DEFECT NOTIFICATION

Safety Recall

SR11-52A

FUSE BOX CONNECTIONS • INSPECT AND TORQUE TIGHTEN 9700 (B13R)

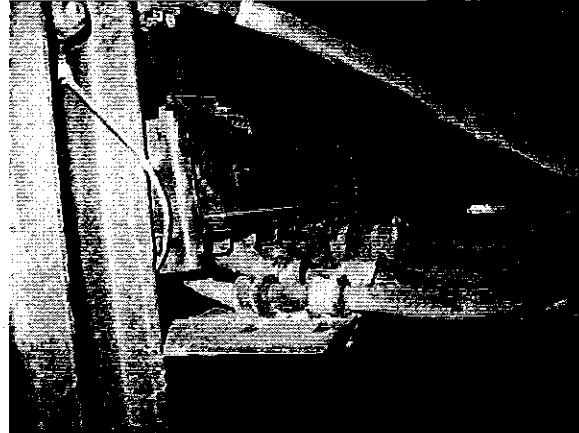
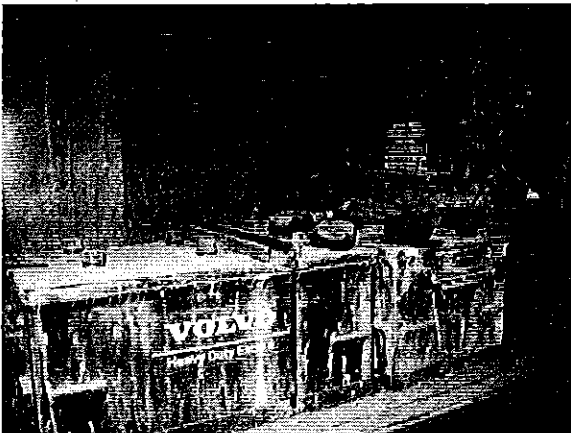
On the vehicles affected by this bulletin, there is a possibility of poorly tightened nuts on the front and rear fuse boxes connections. Symptoms could be poor A/C performance or bad startability. In worst case, this could lead to bad contact, sparks, excessive heat development and melting of terminal sleeves.

All vehicles concerned shall be inspected as soon as possible and if needed, rectified.

Fuse box connections, inspect and torque tighten

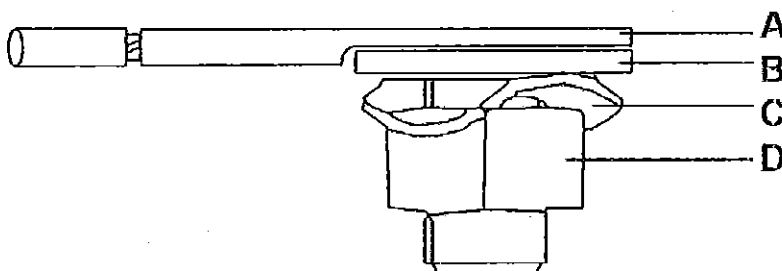
2. Check for any damages, inspect and torque tighten all cable connections on front fuse box. See method below. Check also clamping to the bracket of all connected cables and remedy when necessary.

- A. Cable terminal
- B. Flat washer
- C. Spring washer
- D. Nut

Check for correct position of washers (B, C) and torque tighten all cable terminals. Make sure the specified tightening torques are obtained.

29903651

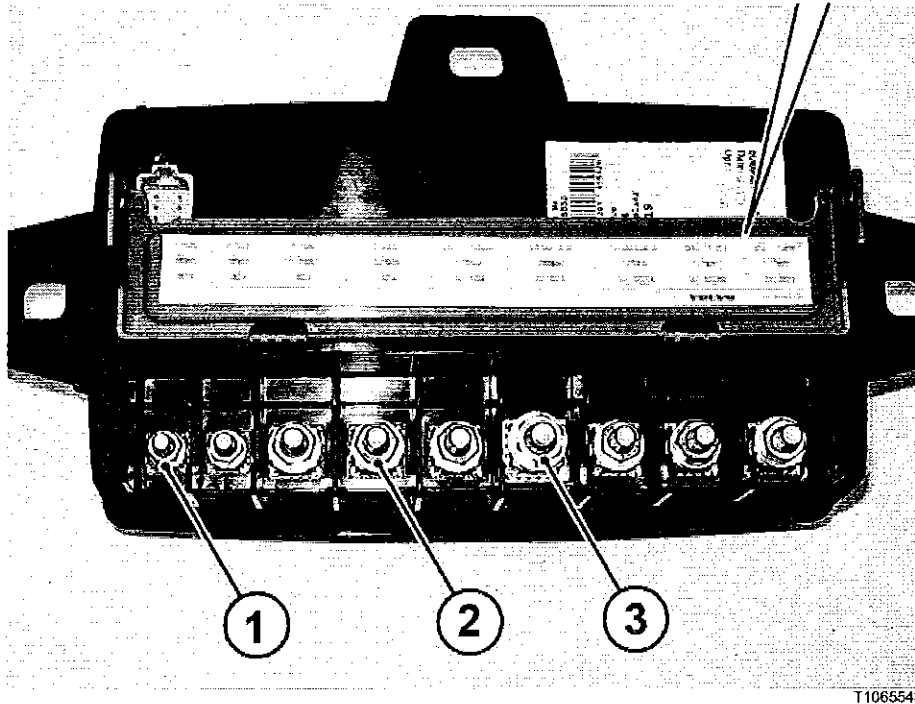
F106	F105	F104	F103	DIST. UNIT	STARTER	CHARGER	BATTERY	DIST. UNIT
16Nm	16Nm	31Nm	31Nm	31Nm	42Nm	31Nm	31Nm	31Nm
30+	30+	30+	30+	XC104	XC103	XC102A	XC102B	XC101

1. M8 screw cable terminals: 16 Nm±10% (12 lb-ft±10%)
2. M10 screw cable terminals: 31 Nm±10% (23 lb-ft±10%)
3. M12 screw cable terminals: 42 Nm±10% (31 lb-ft±10%)

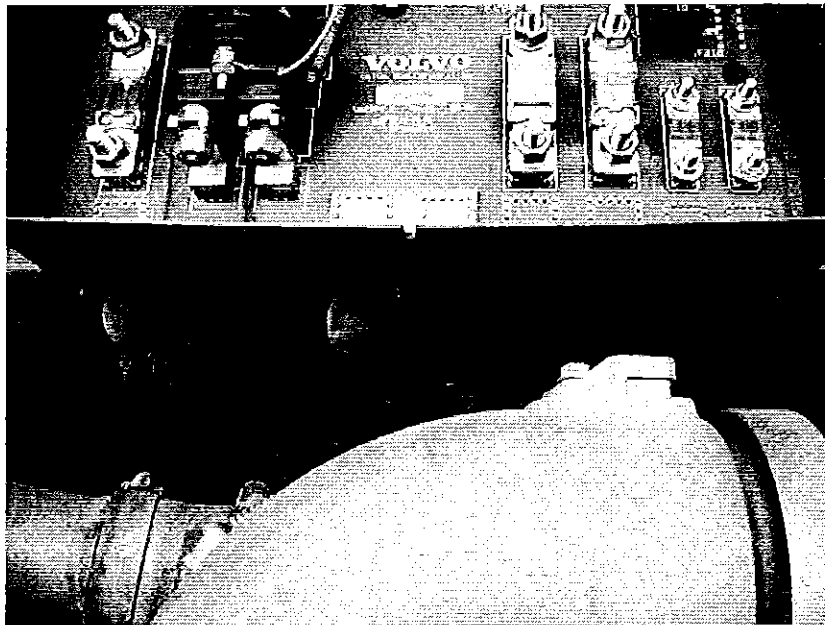
4. Check for any damages, inspect and torque tighten all cable connections on rear fuse box. Check also clamping to the bracket of all connected cables and remedy when necessary.
